ROLLING MEADOWS
SAN ANTONIO, TEXAS
MASTER DEVELOPMENT PLAN

Re: **Rolling Meadows (Amending)**

MDP # 760-B

The City Staff Development Review Committee has reviewed **Rolling Meadows (Amending)** Master Development Plan **M.D.P. # 760-B**. Please find enclosed a signed copy for your files. Your plan was accepted, however please note the following:

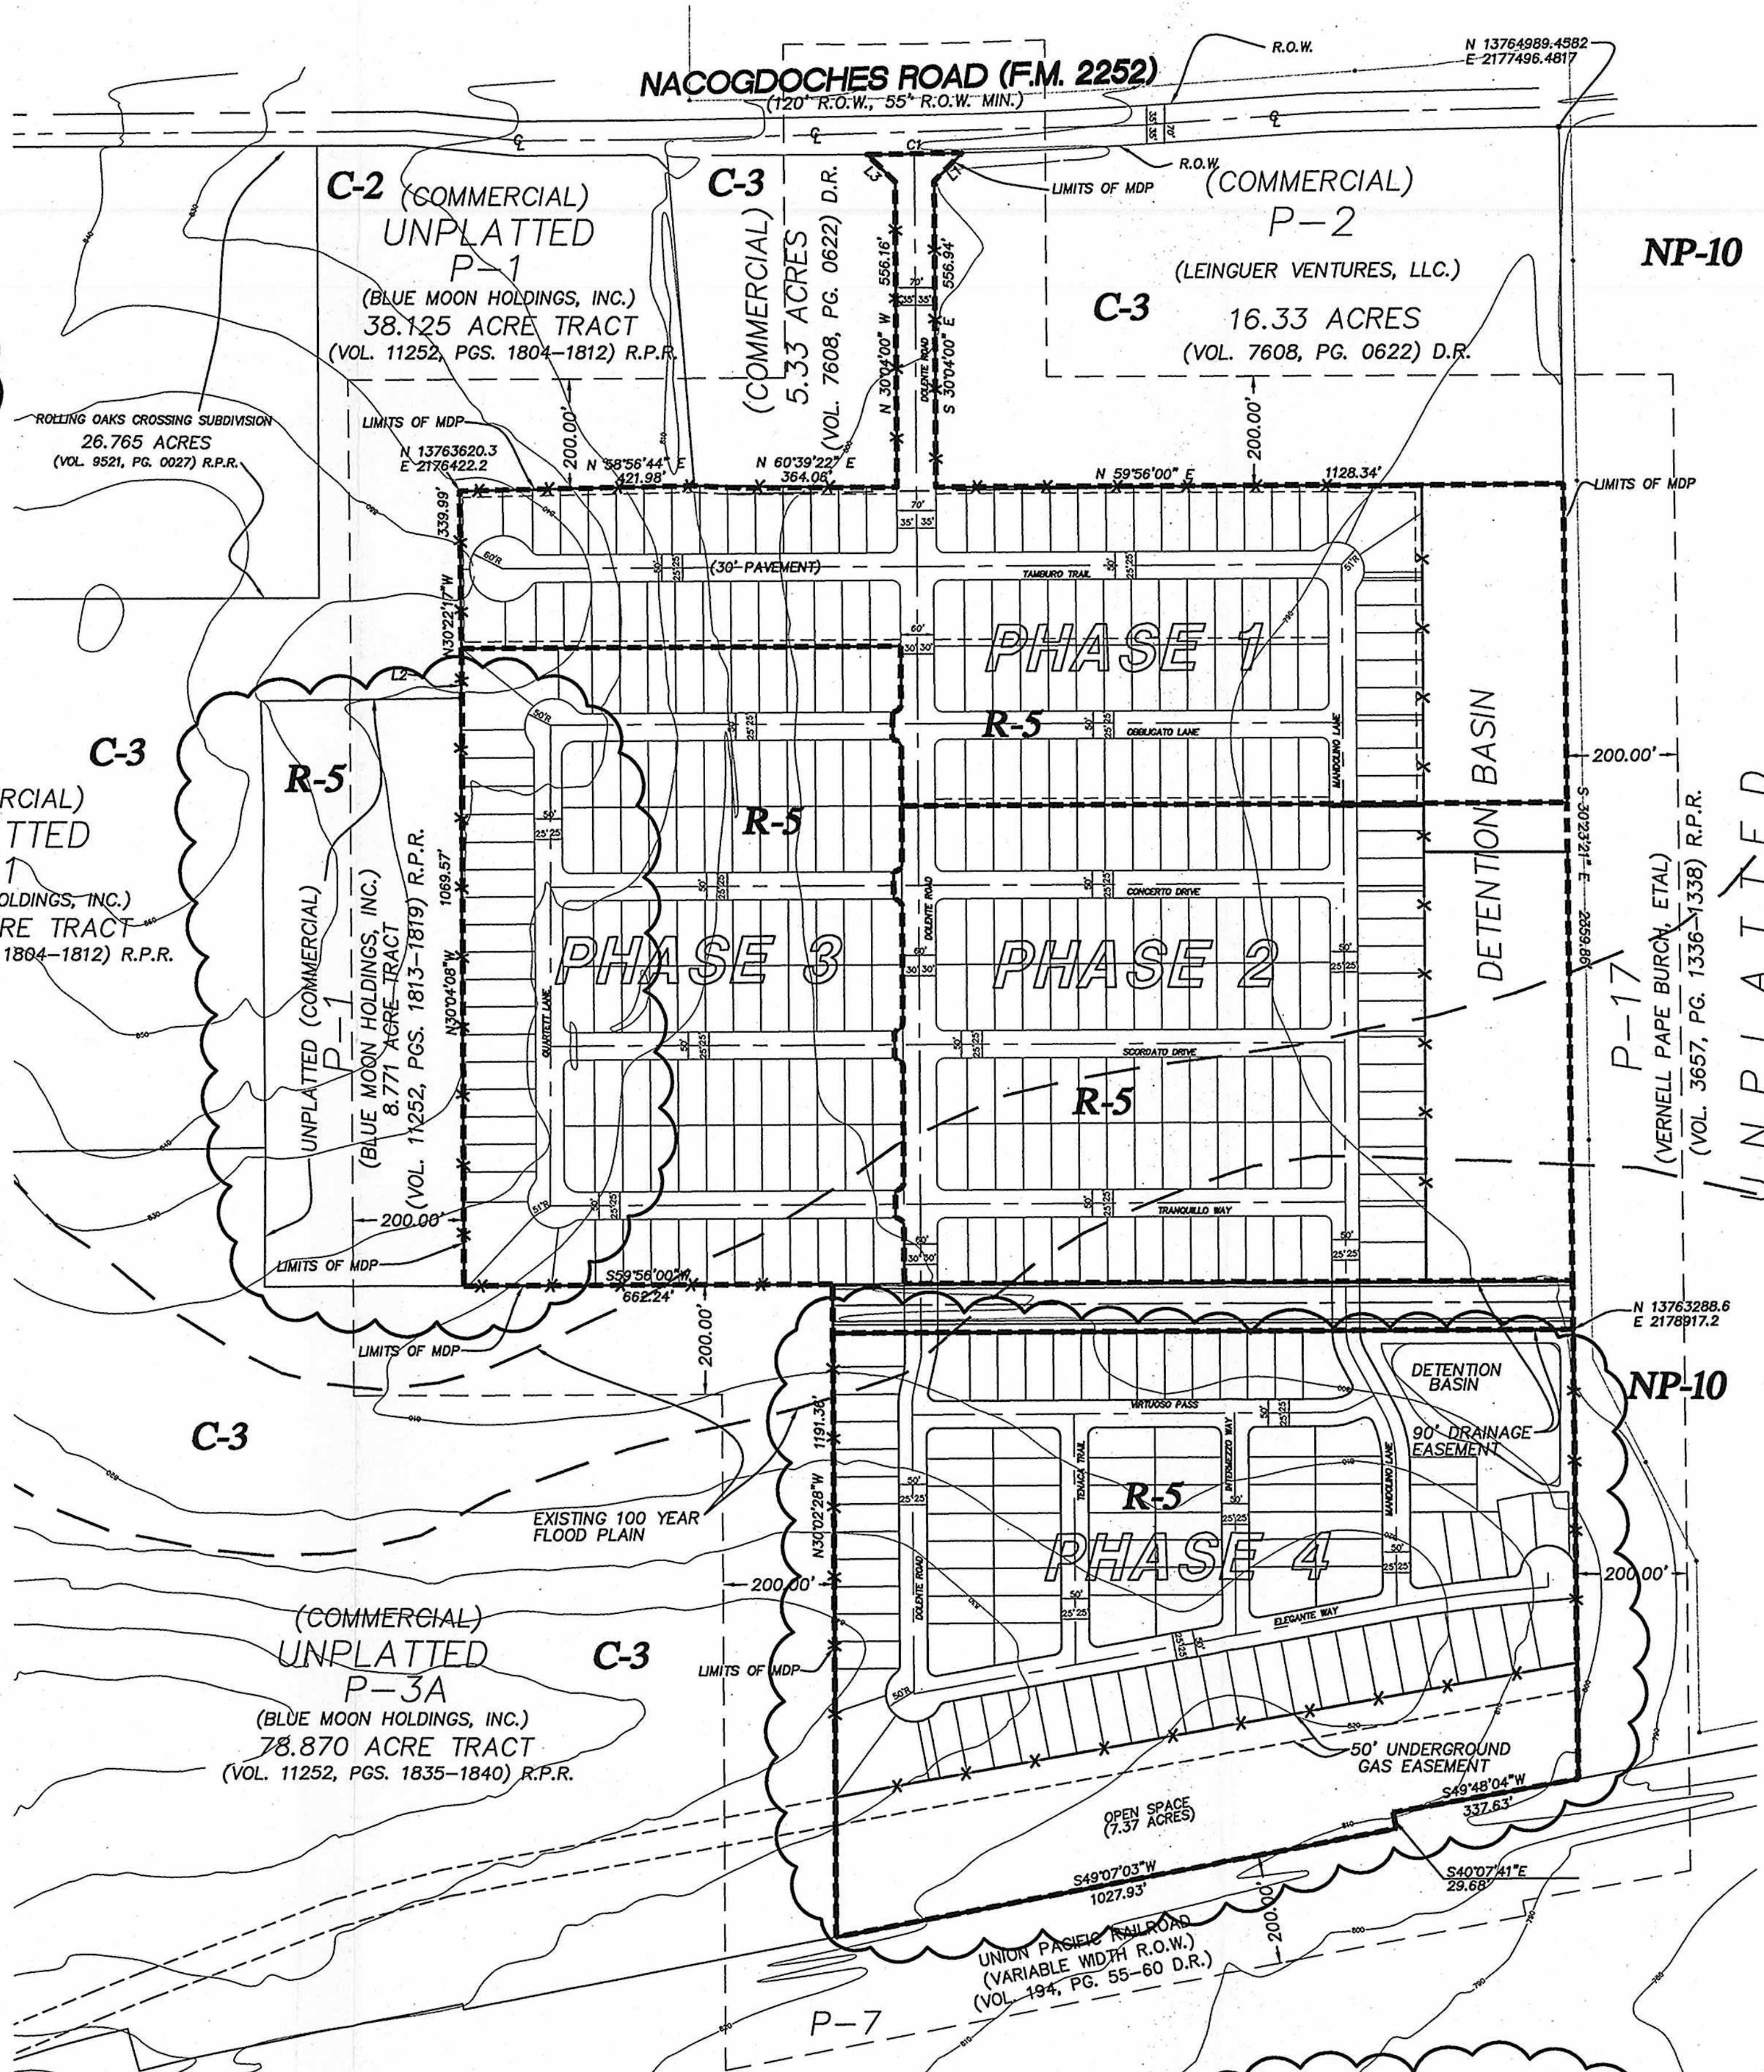
- In consideration of public safety and convenience, excessive grades by reason of topography should be avoided in street layouts and arrangements.
- Any access and R.O.W. issues along state facilities will need to be resolved with the **Texas Department of Transportation (TXDOT)**. For information about these requirements you can contact TXDOT at 615-5814.
- **Historic Preservation:** The Texas Sites Atlas indicates that no archaeological/architectural sites have been previously identified within the above referenced property. However, staff of the HPO believe there is a **high probability** that the property may contain sites, some of which may be significant. An historic agricultural complex may be located within the project area.

The DSD – The DSD – Traffic Impact Analysis & Streets Division has reviewed the Level-1 Traffic Impact Analysis (TIA) and the MDP plan for Rolling Meadows MDP. The analysis indicates compliance with TIA Ordinance 91700 and the UDC.

- shall provide clear sight distance on all existing and proposed roadways in order to provide adequate obstruction free viewing distance for approaching traffic. All signage, landscaping, and improvements shall be selected and located so as to not block these clear sight distance areas.
- The developer shall be responsible for providing a right-turn deceleration lane as well as a left turn lane on Nacogdoches into the subdivision, with storage lengths and bay taper as it relates to the submitted TIA traffic counts, (202 right turn movements and 67 left turn movements)(Uniform Development Code (UDC)-35-502(a)(7), subdivision C.
- Sidewalks along all interior and exterior roadways are to be installed in accordance with UDC 35-506(q).

- This project will be subject to the Streetscape standards and 2003 Tree Preservation ordinance. For information about these requirements you can contact **Tree Preservation** at 207-0278.
- I would encourage you to work closely with the school district, so that they can plan accordingly.
